AGENDA
CITY OF CREVE COEUR
PLANNING AND ZONING
300 NORTH NEW BALLAS RD
MARCH 6, 2023
6:00 PM

#23-004: AN APPLICATION FOR AN AMENDMENT TO THE MERCY HOSPITAL MASTER SIGN PLAN TO INCLUDE ADDITIONAL SIGNAGE FOR THE MERCY HOSPITAL BALLAS CAMPUS LOCATED AT 701 SOUTH NEW BALLAS ROAD AND ASSOCIATED LIGHTING PROPOSAL

BACKGROUND AND MASTER SIGN PLAN AMENDMENT PROPOSAL

Figure 3: Proposed signage for the west elevation.

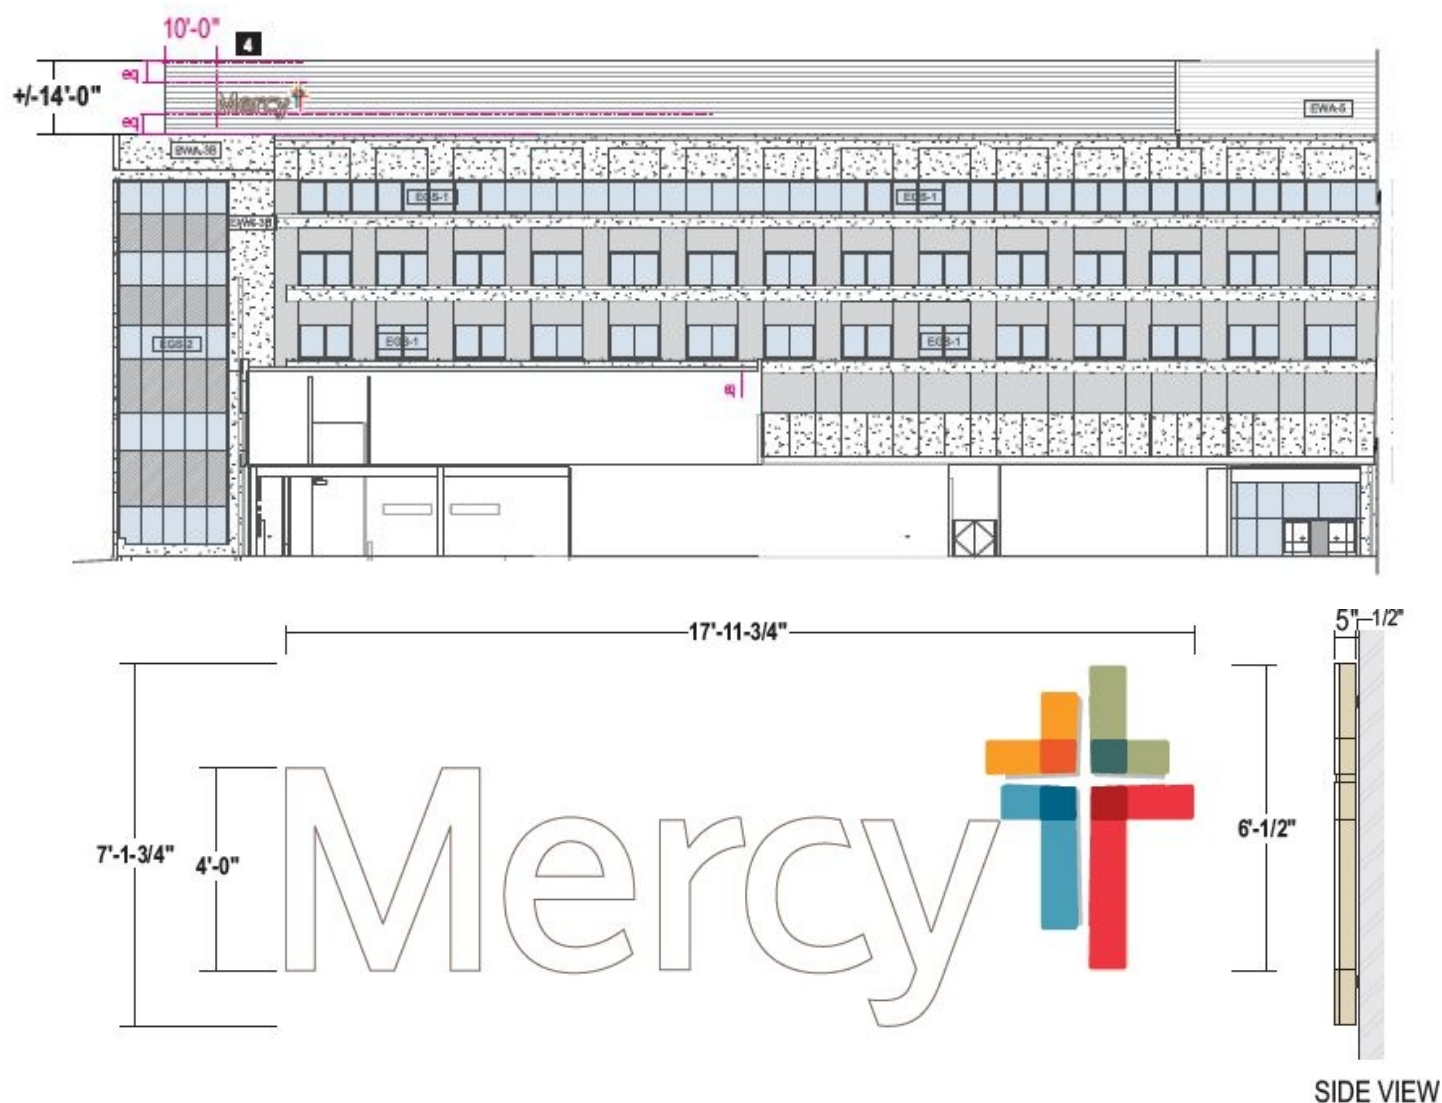
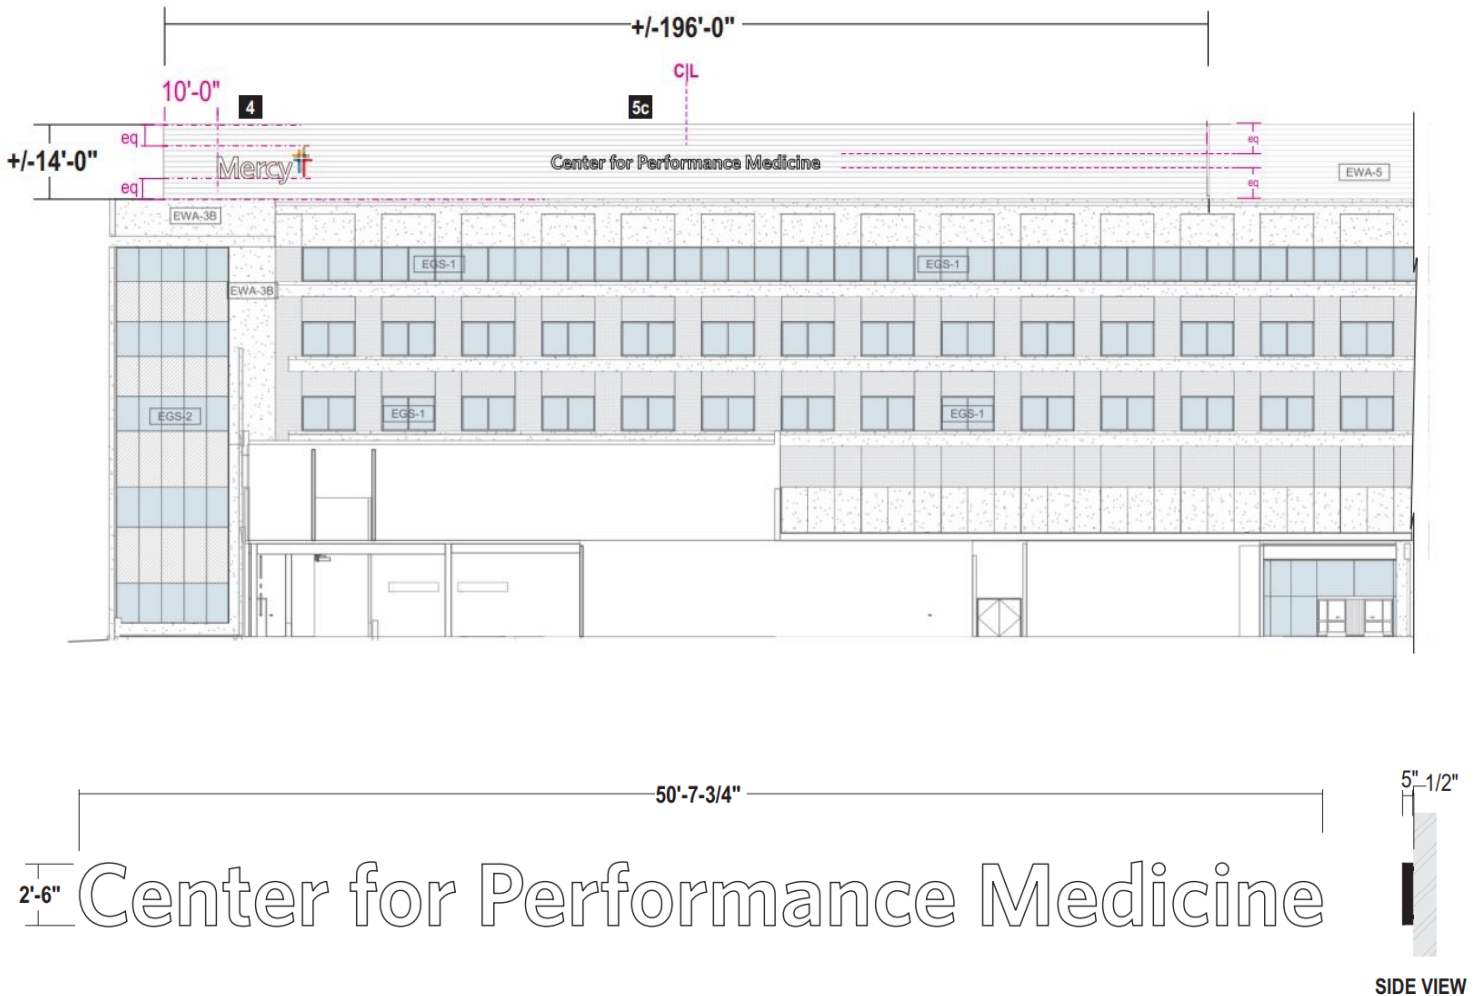
The sign plan amendment proposes one new sign on the west elevation where no sign was previously approved. The sign would be placed on the mechanical screen opposite the approved “Mercy” logo sign. The proposed sign would read “Center for Performance Medicine” and be a total of 126.6 ft². The new sign is labeled as sign 5c on the site plan. The applicant has explained the sign placement on this façade is needed so that it may be visible for passing motorists from I-270. The approved “Mercy” logo sign is 128.5 ft² ; bringing the total proposed signage area for the west elevation to just over 255 ft². All signage consists of illuminated channel letters in matching font.

Figure 5: Proposed south elevation wall signage.

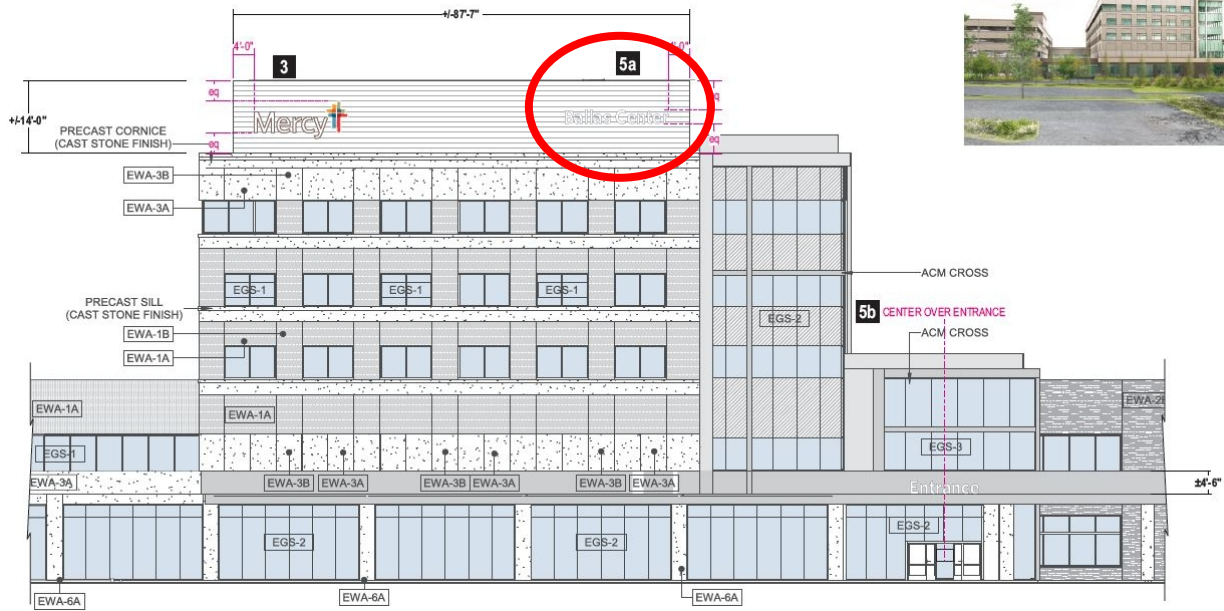
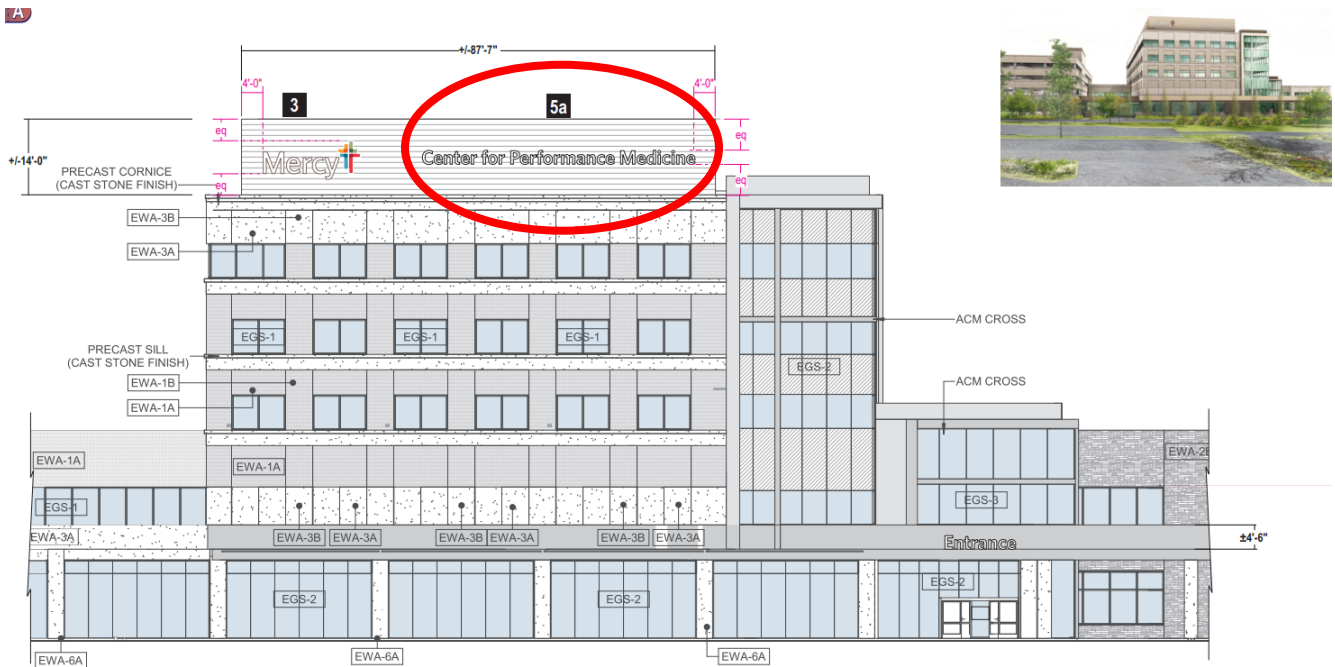
The previously approved signage for the south elevation included two wall signs, one "Mercy" logo sign at 128.5 ft² and one "Ballas Center" sign at 53.1 ft². An "Entrance" sign above the main entry was also approved at 33.3 ft². All three signs are illuminated channel letters totaling 214.9 ft². This amendment proposes to enlarge the sign area for sign 5a from 53.1 ft² to 126.6 ft² to accommodate the new name change. This proposal would bring the overall wall signage square footage to just over 288 ft² on the south elevation. Signs 5a and 5c are identical in size and message.

The proposed signs are well-designed and in similar style and use of materials to the existing signage on the Mercy Campus. Although the size of the signage on the south elevation is of concern to staff due to the scale of that elevation, staff finds that the existing and proposed signage is mostly in keeping with the Design Guidelines and the Comprehensive Plan and should not have a negative impact to the adjacent residents.

Staff encourages the Planning and Zoning Commission to discuss the scale of the sign proposed for the south elevation and consider reducing the square footage of the sign to be more compatible with the size of the area for which it is proposed. Staff recommends the sign on the south elevation be reduced to 100 square feet in order to be more appropriately scaled for this façade and to not compete with the logo sign.

Figure 7: Proposed south elevation signage (top) compared to same sign in 50 ft² (bottom).

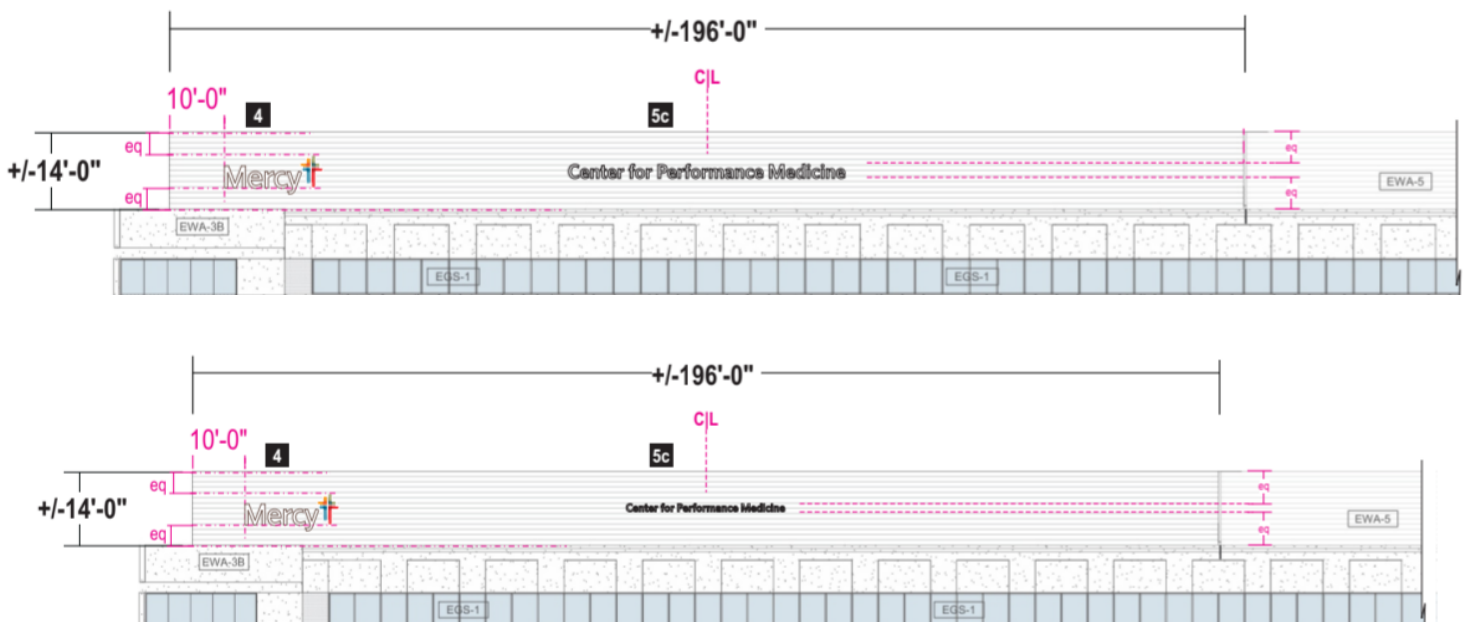
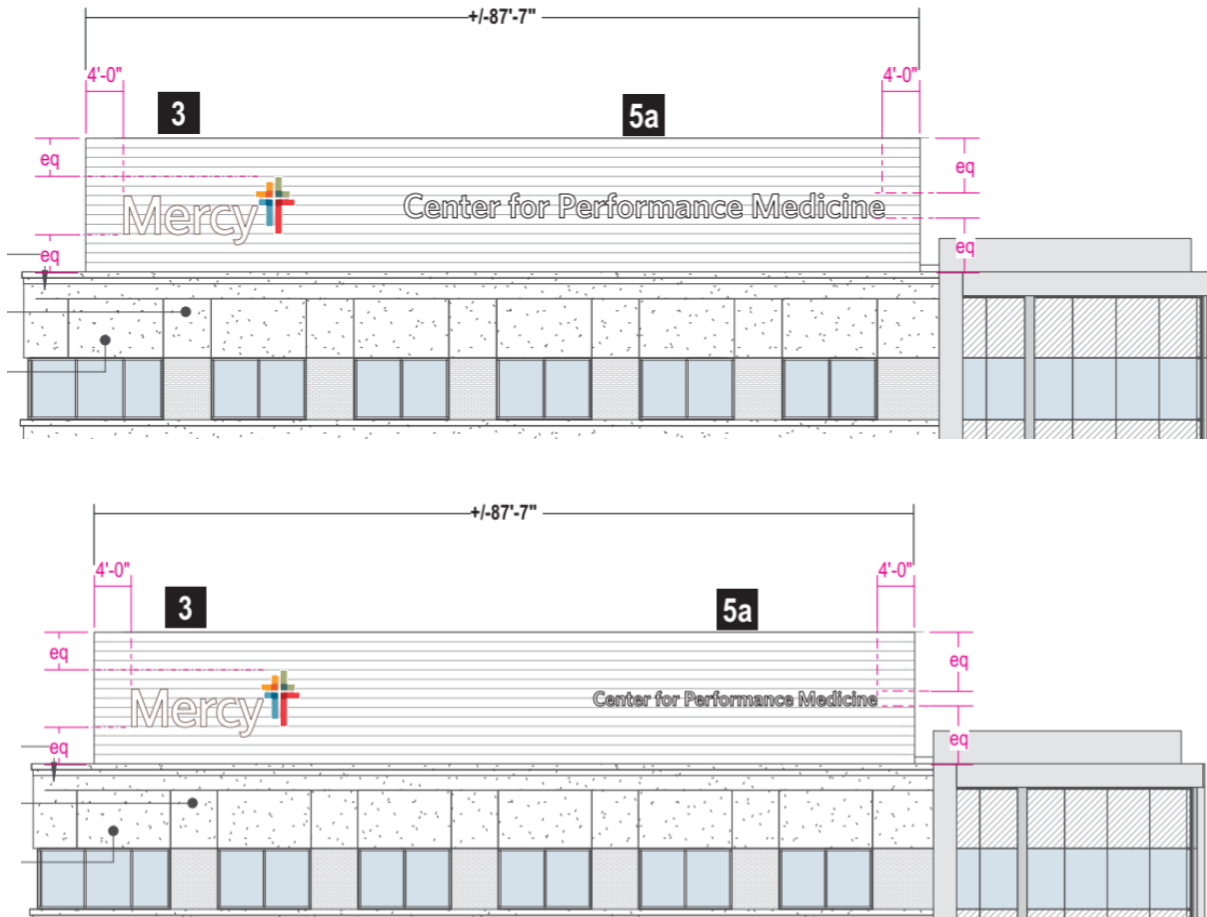
Without a Master Sign Plan, a similarly sized office building would be allowed, one sign per street facing façade, with a maximum of 70 ft² per sign per Section 405.950(D)(2). The current signage code does not reflect the signage needs for large-scale campus uses, such as a hospital, and therefore a Master Sign Plan is recommended per Section 405.955. The previous amendment provided additional signage beyond the allowance of one per street facing façade and proposes more square footage than would be allowed for a similar building but staff felt the size and location were not overly distracting or out of character for a building of this size. The request for additional signage reflecting the specific building name on the west elevation does not seem excessive given the size and placement requested. The new sign does not appear to clash with the “Mercy” logo sign or compete for attention and appears to be appropriately scaled for the façade. The size of the sign proposed for the south elevation is a concern for staff. Staff would be more comfortable with a larger sign than was previously approved to support the new building name if the square footage were to be reduced so that the scale of the sign appeared more proportional to the location on the building and the proposed “Mercy” logo sign. The space on the south elevation is significantly smaller than on the west elevation and staff would prefer to see this sign scaled down so as not to compete for attention with the logo sign. A size reduction to 100 square feet might be more appropriate. In response to a request from staff to reduce the size of the signs, the applicant provided a rendering to show size comparisons between the proposed sign and a sign in the same font but no larger than 50 ft² as shown in Figures 6 and 7.
